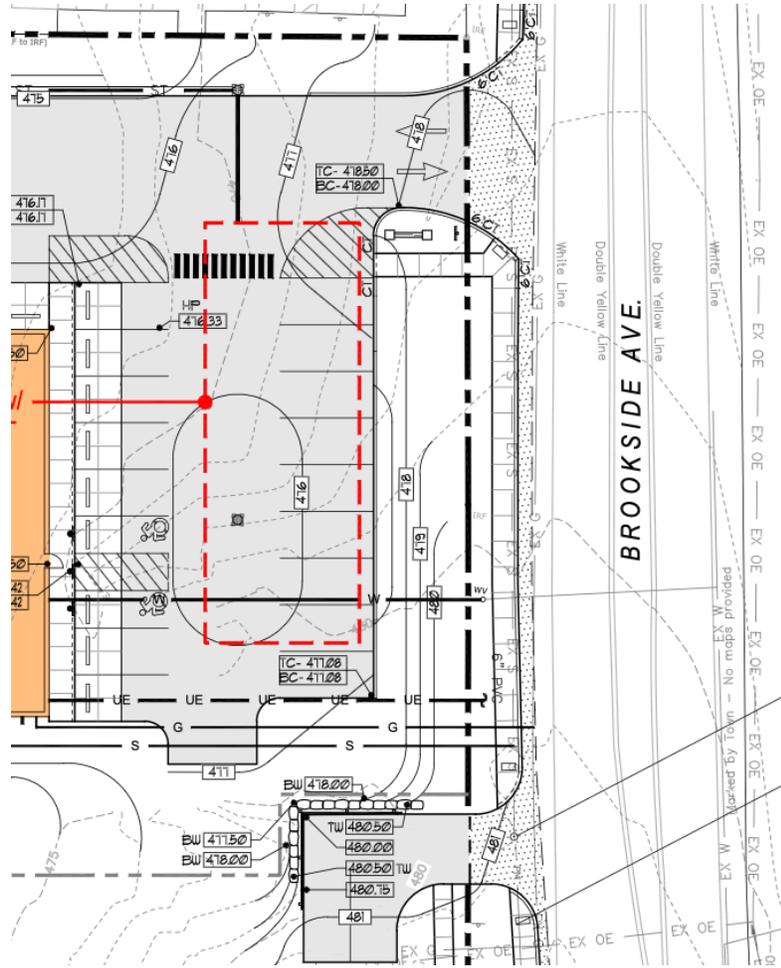
At the June 22nd meeting, I believe I heard the applicant state that there would be a raised berm between Brookside Ave and the parking lot, that would partially obscure the parked vehicles from the view passers by. According to his "Grading, Drainage and Utilities Sketch Plan dated 6-16-21, the elevation at south west corner is 481' (edge of Brookside Ave.). The elevations depicted decrease as one travels westerly onto the site. - That hardly seems to be a "raised berm." The front parking lot is at a nominal elevation of 476 feet - two to five feet below the western edge of Brookside Ave. The stated goal to obscure the parked vehicles from the view of people passing the site does not appear to be achieved by this plan.

I haven't seen on these site plans depictions of the structures on adjacent properties, as required by Village of Chester, NY Code § 98-28-F.(1):

Along with the general lack of important dimensions, where are the metes and bounds of the existing and proposed parcel boundaries?
